UNITED STATES PATENT AND TRADEMARK OFFICE

APPLICATION NO.	FILING DATE	FIRST NAMED INVENTOR	ATTORNEY DOCKET NO.	CONFIRMATION NO.
10/657,375	09/08/2003	Werner Heierli	027262-182-D1	9448

Office Action Summary	Application No. 10/657,375	Applicant(s) HEIERLI, WERNER 	
	Examiner Chapman E Jeanette	Art Unit 3635

gc ^{46,47}
Claims 25,37-39, 41,^{46,47}66 and 68 are rejected under 35 U.S.C. 102(b) as being anticipated by Monachino (6408581). Monachino et al discloses a method of forming a hybrid arched overfilled bridge comprising:

PATENT COPIES W/ANNOTATIONS

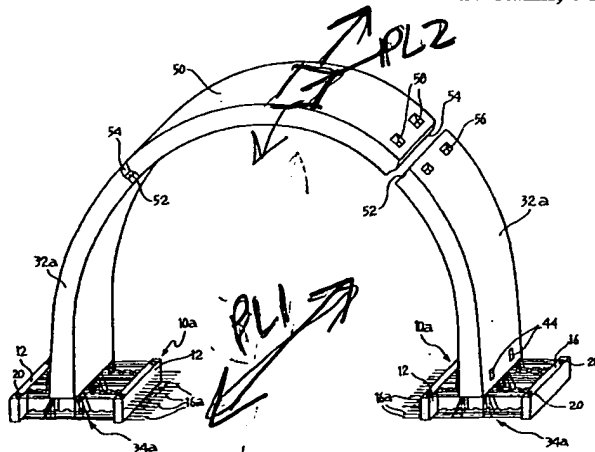
- Defining a first pathway PL1; see annotations on patent copy;
- Defining a second pathway PL2 spaced above the first: see annotations on patent copy;
- Providing a plurality of precise side elements 32a;
- Erecting the precise side elements in two rows along the first pathway to extend toward the second pathway PL2;
- Casting in place a crown sector element between the two precast side elements to extend from one side element to the other so that the crown sector with the two side elements form a bridge;
- Forming a structural connection or shrinkage joints between/ in the crown sector and the two side elements; see figure 11;
- Figure 11 shows the crown sector with beveled edges

- At some time in place the precast side elements were lifted and set in place in footings 34a;
- Casting in place one or more crown sector elements between two space apart rows of precast side elements such that the one or more crown sector elements connect at the two space apart rows of side elements to define a bridge over the first pathway;
- Multiple crown sector elements are cast in place and each crown sector element extends along the first pathway for a length that connects multiple precast side elements of each row.
